**WILSONVILLE CITY HALL
DEVELOPMENT REVIEW BOARD PANEL A**

MONDAY, FEBRUARY 8, 2016 - 6:30 P.M.

A. Resolution No. 323.

Exhibit A1
Staff Report
Wilsonville Planning Division
Advance Road Middle School

LU2.03

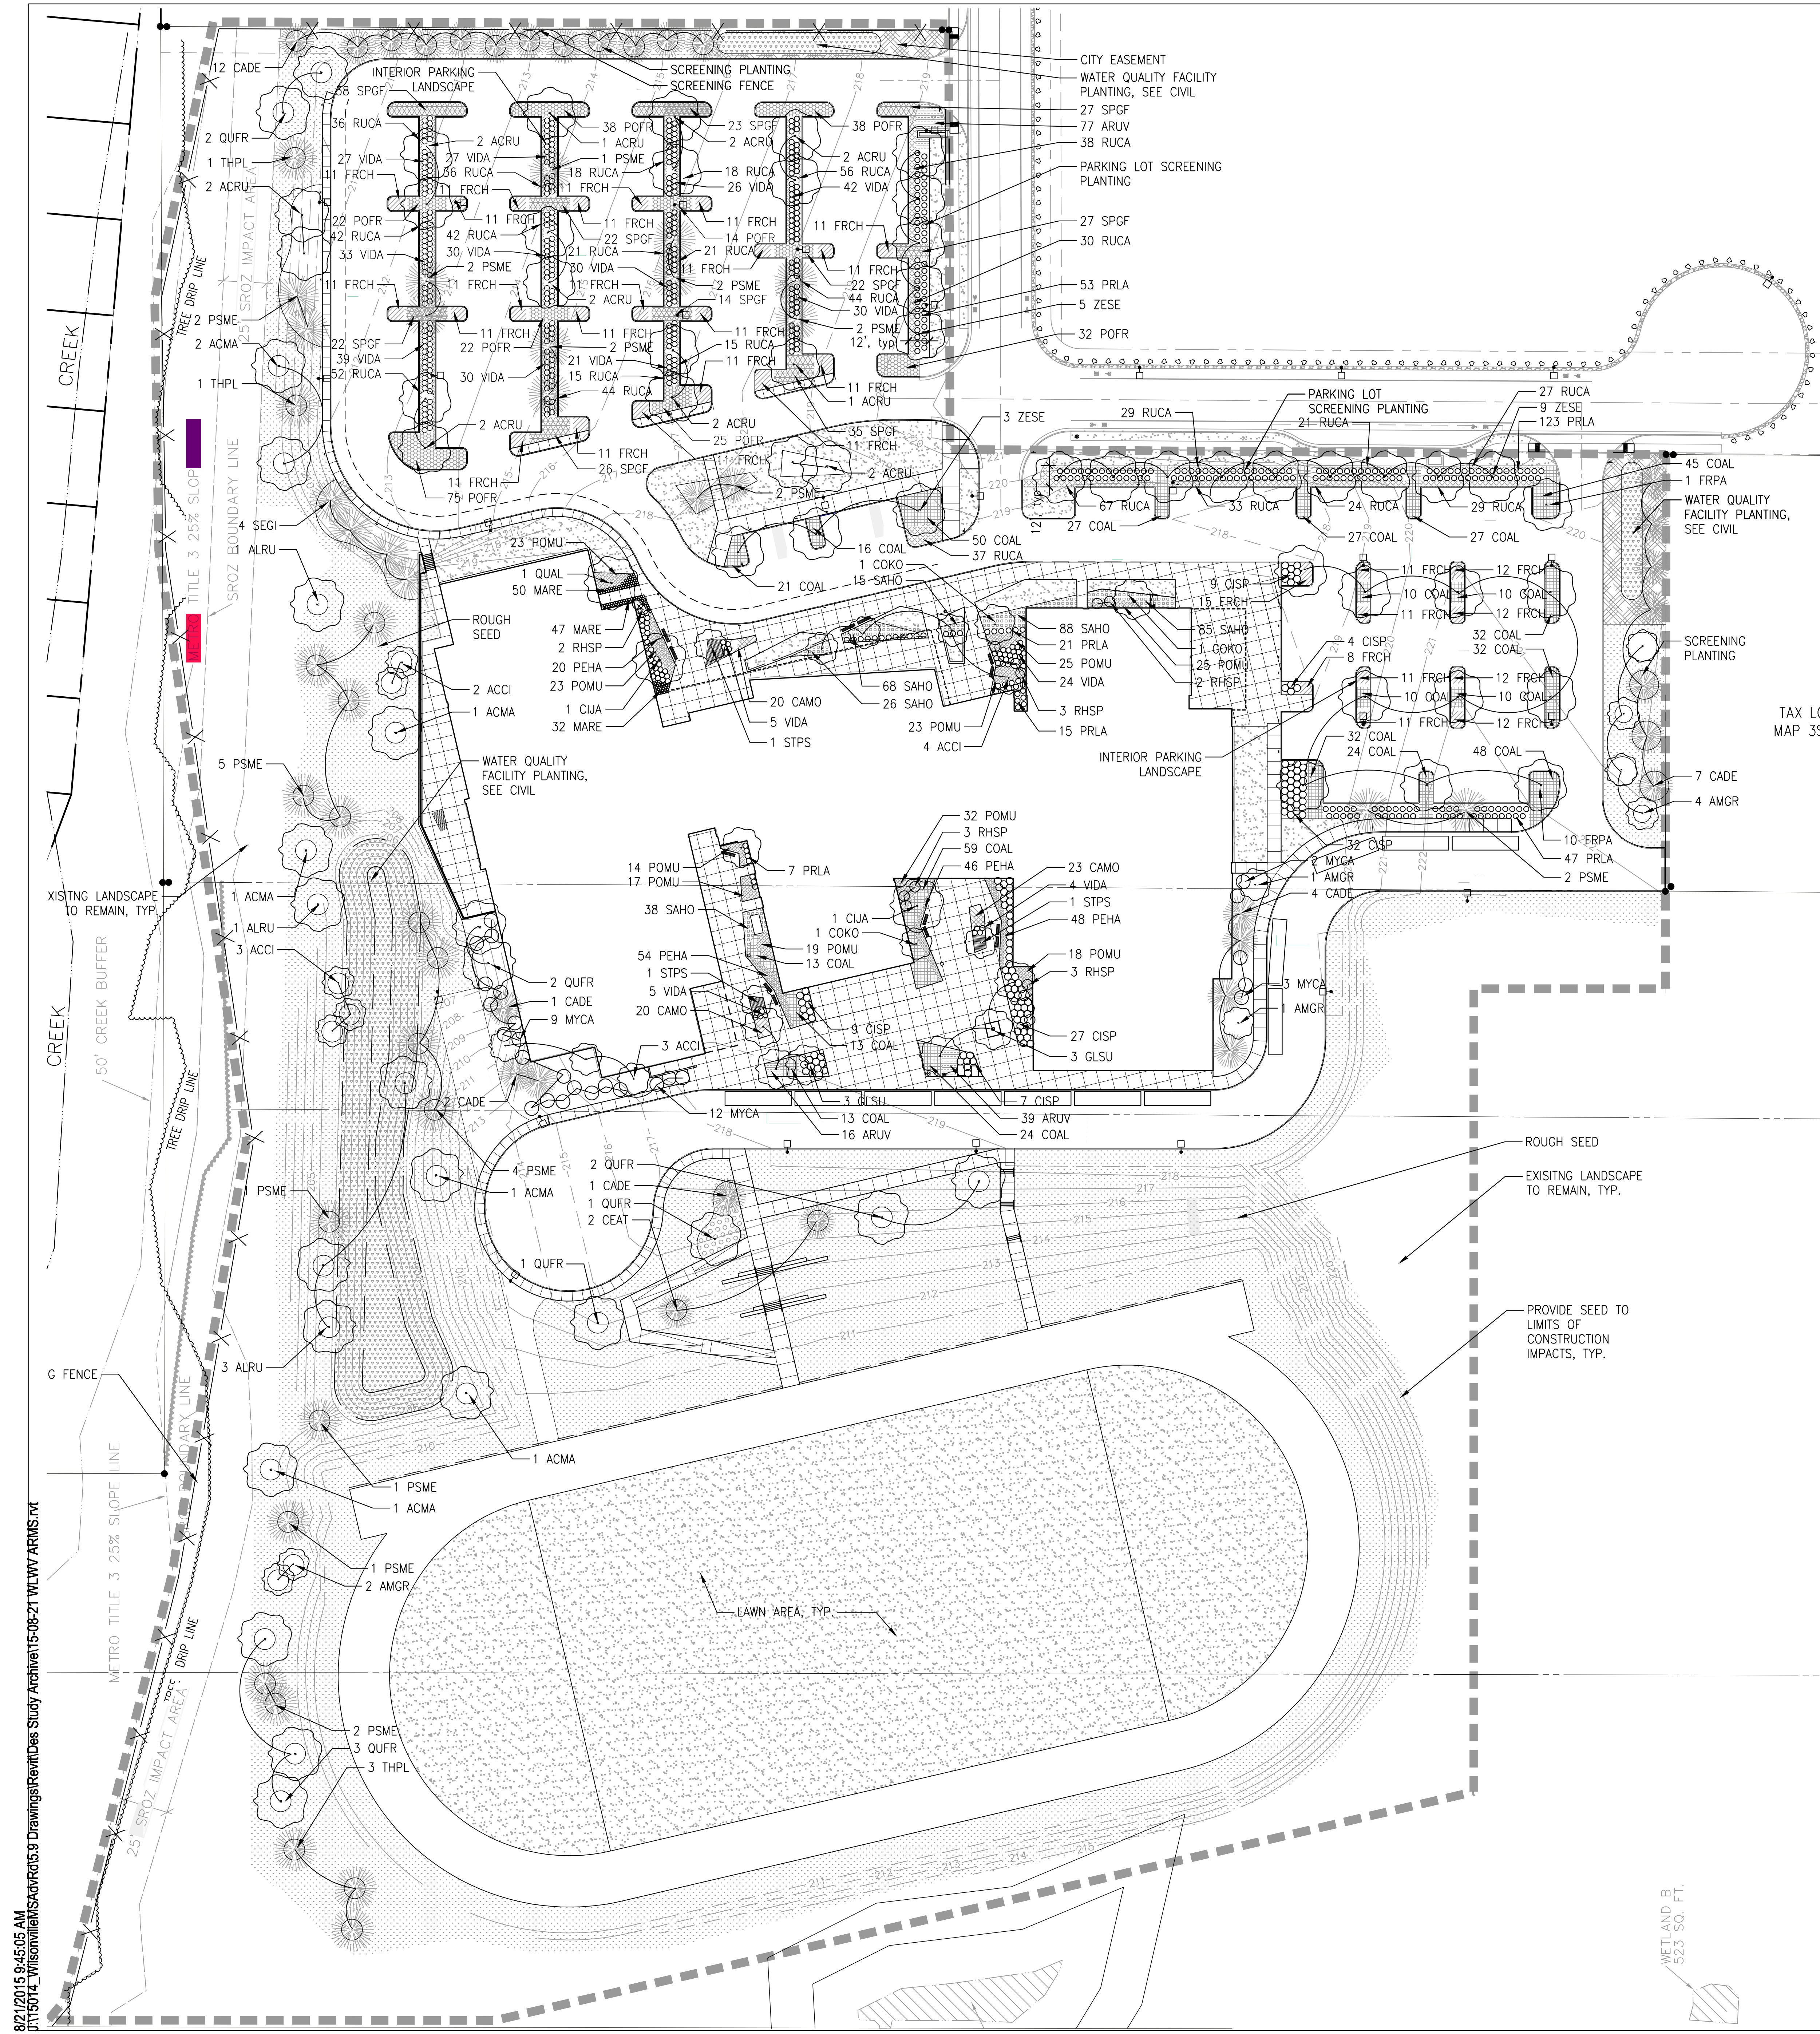
Details of Finding: As indicated on the applicant’s sheet LU2.03 in Exhibit B2 a variety of plant materials are proposed to create the variations in forms, textures, and heights required by this subsection.

Details of Finding: Applicant’s sheet LU2.03, planting plan in Exhibit B2, provides the required information.

LU3.03

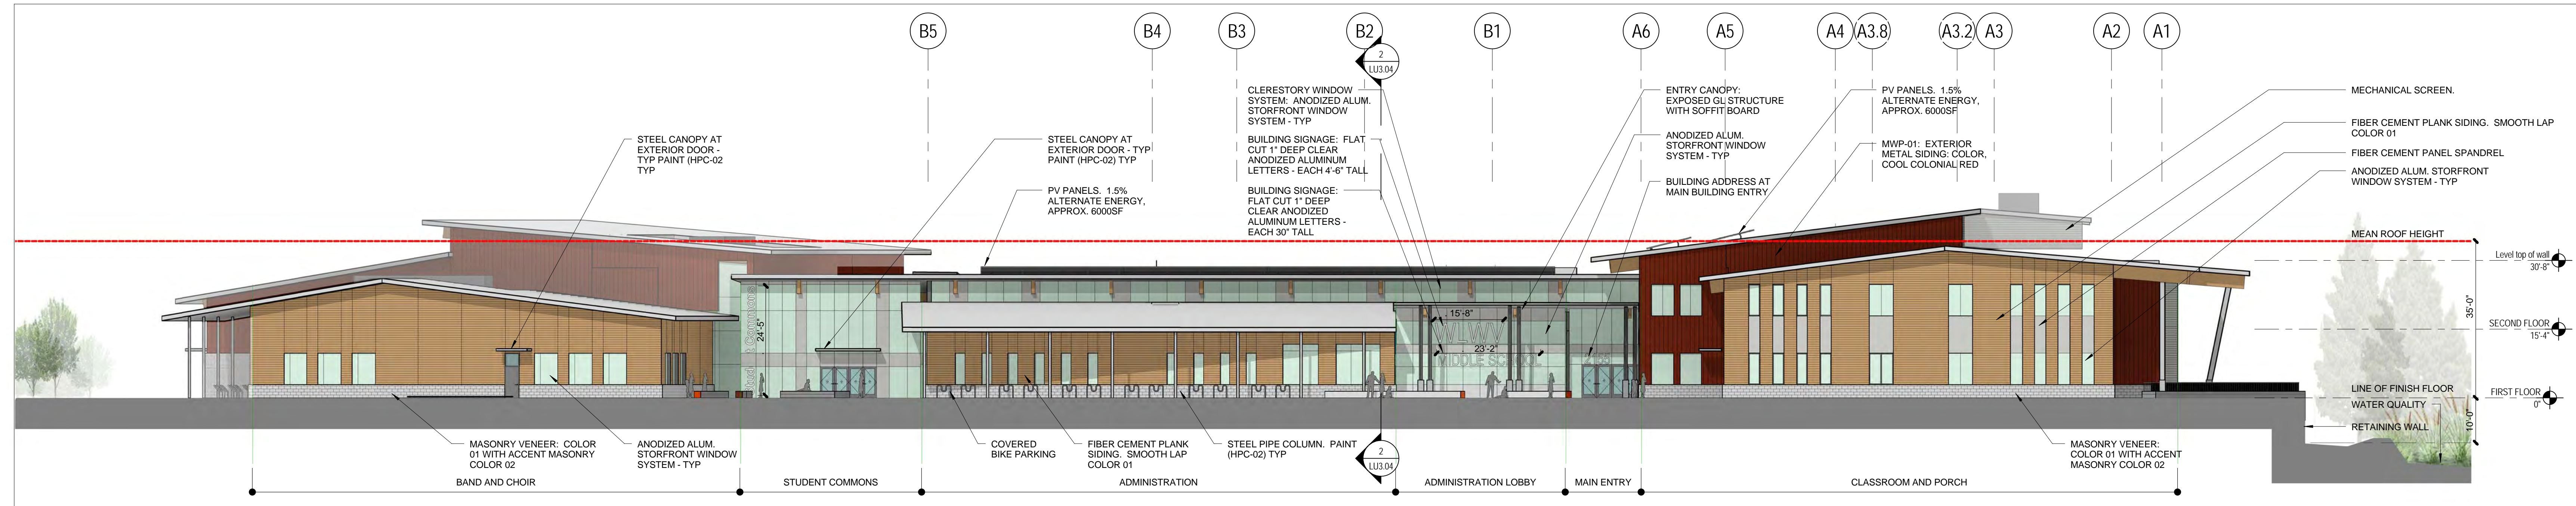
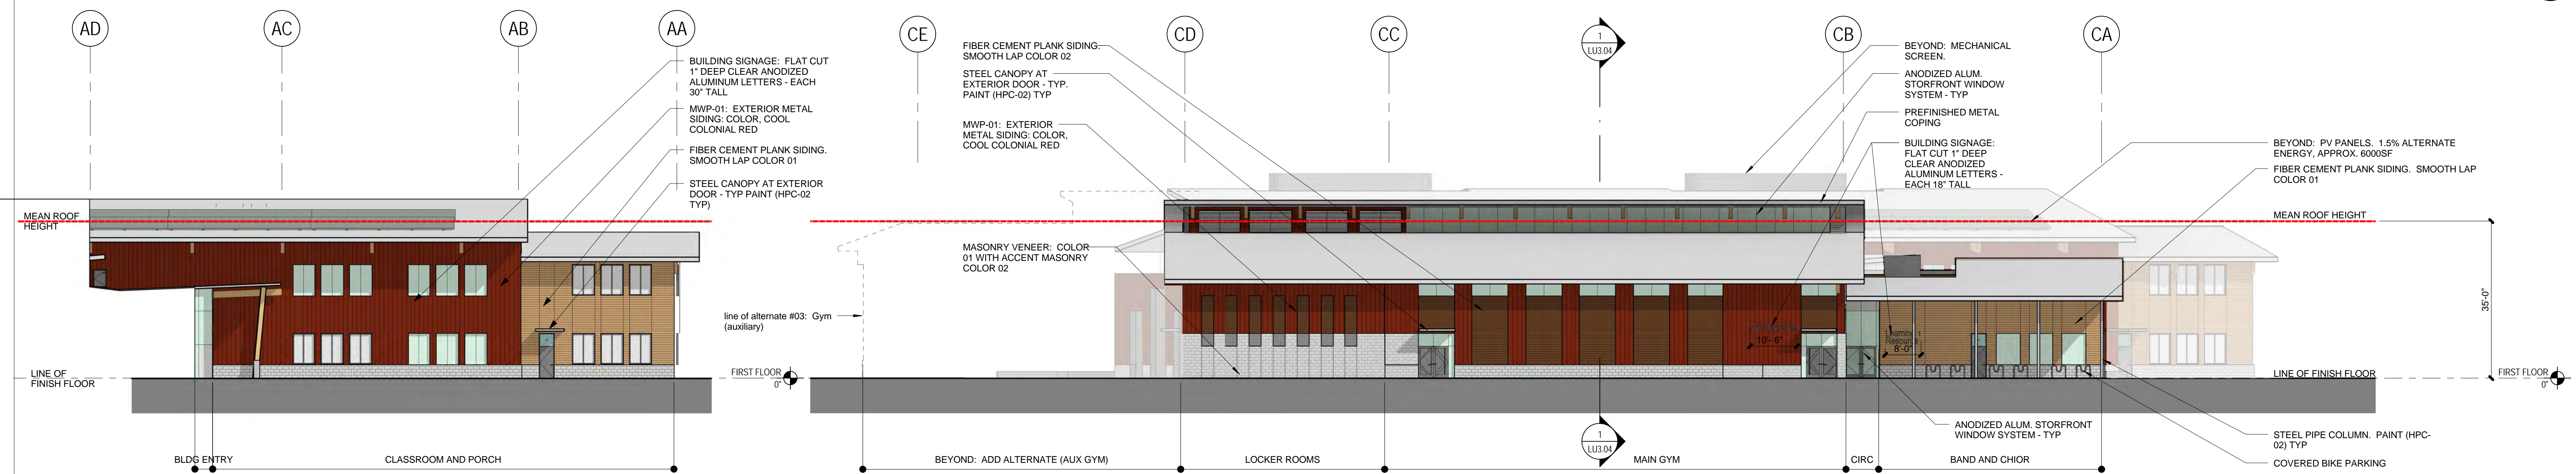
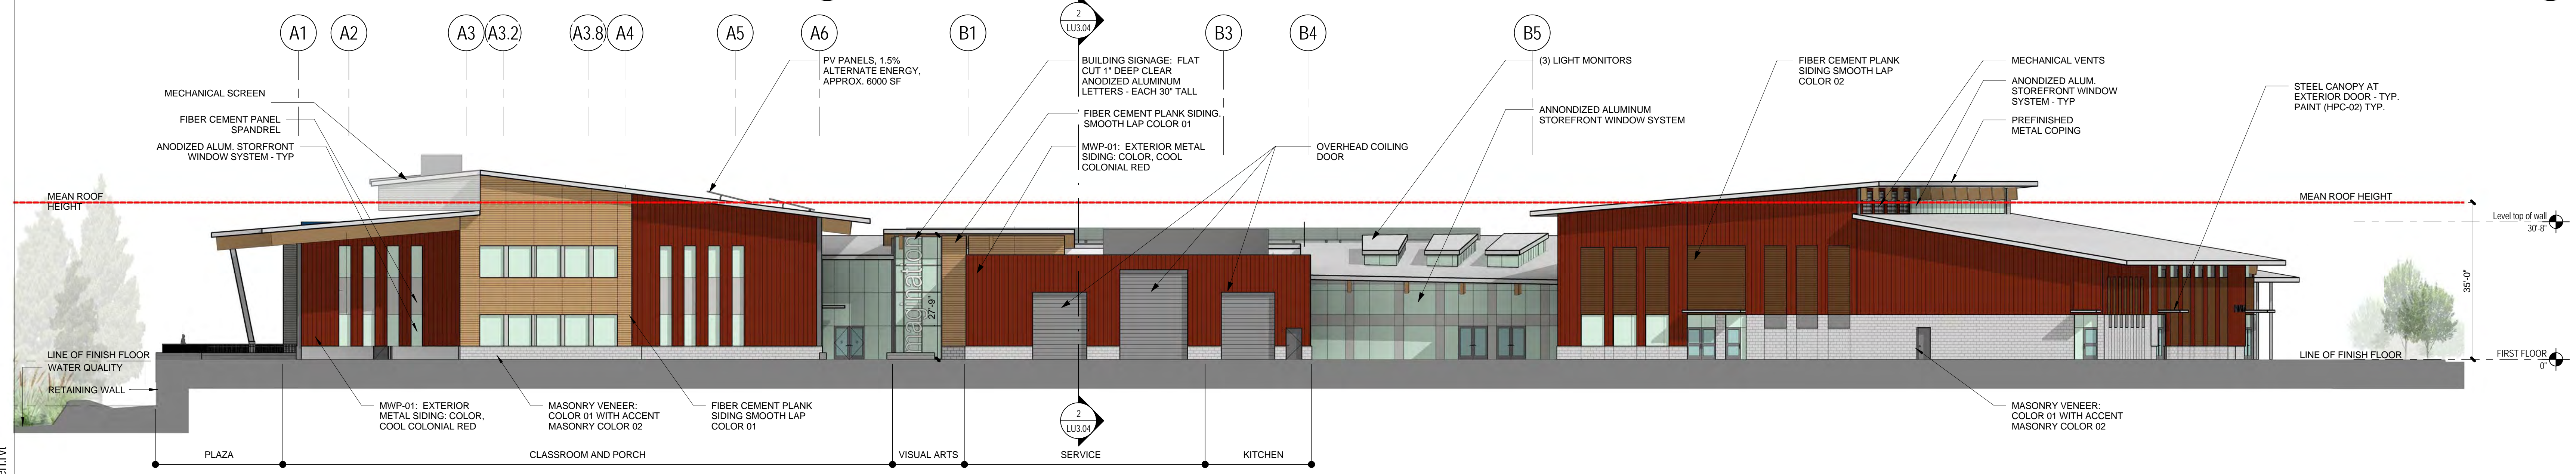
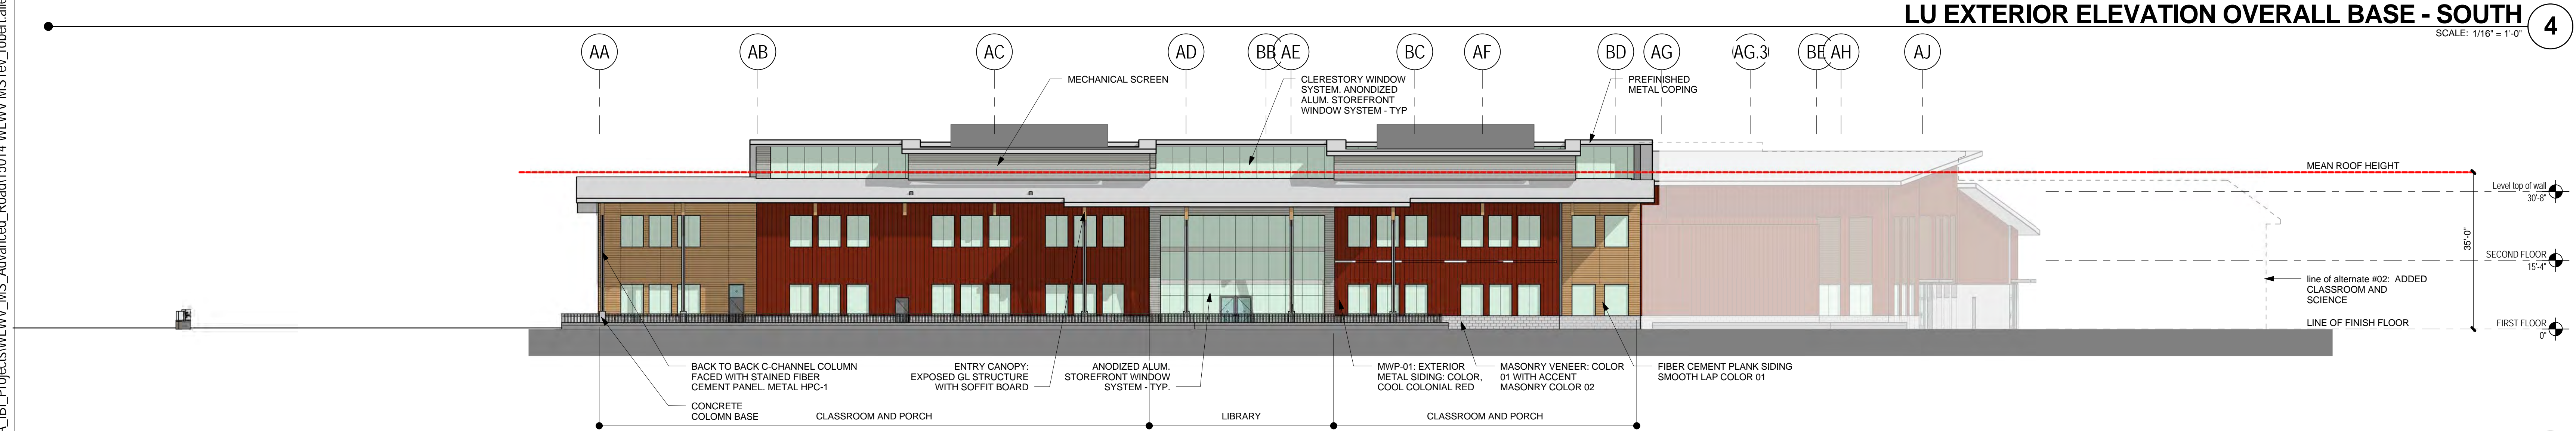
- The north building elevation is proposed to have three wall signs:
 - School name totaling approximately 130 square feet near the main building entrance. The design and materials are noted on Sheet LU3.03. The actual sign size will be partially determined by the school name, which is yet to be determined.

- An address sign also near the main entrance, which is also shown on Sheet LU3.03.
 - A sign identifying the Student Commons near the eastern front entry (Sheet LU3.03). It is proposed to be approximately 50 square feet.

- The east elevation is proposed to have two wall signs to identify the Learning Resource area and Gymnasium (Sheet LU3.03) with approximate sizes of 24 square feet and 16 square feet, respectively.

- The south elevation is proposed to have one sign stating “Imagination” near the southern building entrance (Sheet LU3.03) with an approximate size of approximately 70 square feet
